- 1. Anchor View Estates 2023 Addition; KPB File 2023-116
Fineline Surveys, Inc. / Kimbrell, Beller
Location: Shorebird Lane off the Sterling Highway
Anchor Point Area / Anchor Point APC**

**ITEM #1 - PRELIMINARY PLAT
ANCHOR VIEW ESTATES 2023 ADDITION**

KPB File No.	2023-116
Plat Committee Meeting:	November 13, 2023
Applicant / Owner:	Dmitri Kimbrell and Randy and Sarah Beller, all of Anchor Point, AK
Surveyor:	Dmitri Kimbrell / Fineline Surveys
General Location:	Anchor Point / Anchor Point APC

Specific Request / Scope of Subdivision: The proposed plat will combine four irregular shape lots into two lots.

ANCHOR VIEW ESTATES - 2023 ADDITION,

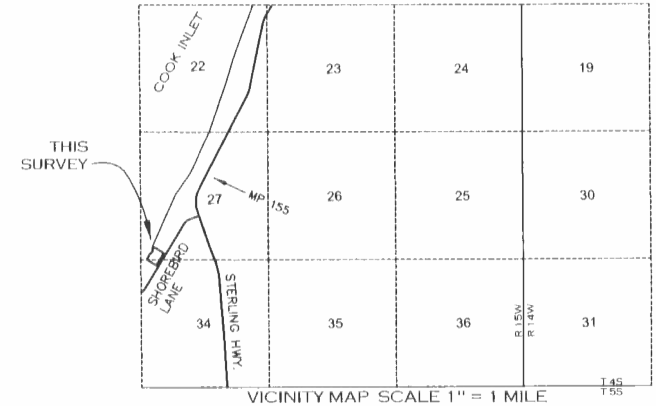
There is a section line easement shown on KPB GIS information but not shown crossing the lots on the parent plat. The parent plat does show the SLE to the east though. ***Staff recommends: the surveyor verify with the State DNR if the section line easement has been vacated through this portion of the sections. If not this needs to be shown on the drawing.***

The subdivision is in a flood hazard area, but not in a floodway. ***Staff recommends: the standard Flood Hazard Notice be added to the plat notes.***

Utility Easements There is a 10' Utility Easement on either side of an existing powerline as shown on the parent plat of Anchor View Estates Subdivision HM76-57 that need to be added to the drawing. There is an easement listed in the certificate to plat at #16, serial number 2003-004614-0, that needs to be added to the drawing and plat notes also.

- Show width of each lot on the drawing.

Staff recommendation: Add the KPB file no of 2023-116 to title block. Add the parent plat number to the legal description.

- add block number to lots labels

Staff recommendation: The easement list at #16 in the certificate to plat need to be shown and added to the plat notes and *comply with 20.60.150.*

- There is a section line easement that needs verification to be shown. There is not enough information in the certificate to plat and should be verified with the DNR.

- *The borough will not enforce private covenants, easements, or deed restrictions per KPB 20.60.170.*

- Under the names under Certificate of Ownership, list the lots being signed for.
- Add the meeting date of November 13, 2023 to the Plat Approval

Staff recommendation: *Correct any overstrikes and comply with 20.60.200.*

ANCHOR VIEW ESTATES- 2023 ADDITION,

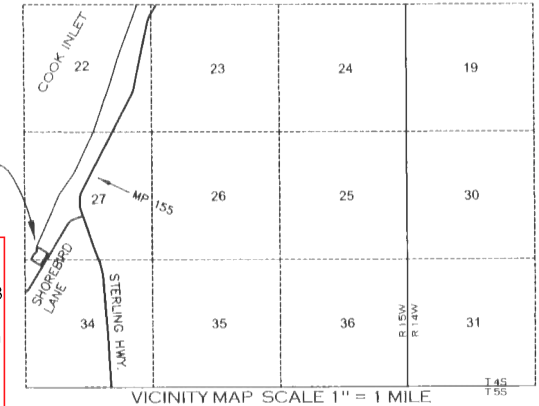
Depict and label the 10 ft. x 205 ft. electric easement adjoining the northeast boundary of Lot 13 per serial no. 2003-004614-0 HM. There is a 5 foot easement within Lot 14 (2003-004615-0 HM) for a full 15 width. The easement within Lot 14 does not need to be shown or labeled on this plat.

Depict and label the underground primary electric line. Provide a label or plat note stating, "The existing underground powerline is the centerline of a 15-foot-wide electrical distribution line easement, including pedestals and transformers, granted this plat."

Depict and label the overhead electric line. Provide a label or plat note stating a 20 foot utility easement, centered on the overhead electric line was granted per plat 76-57 HRD.
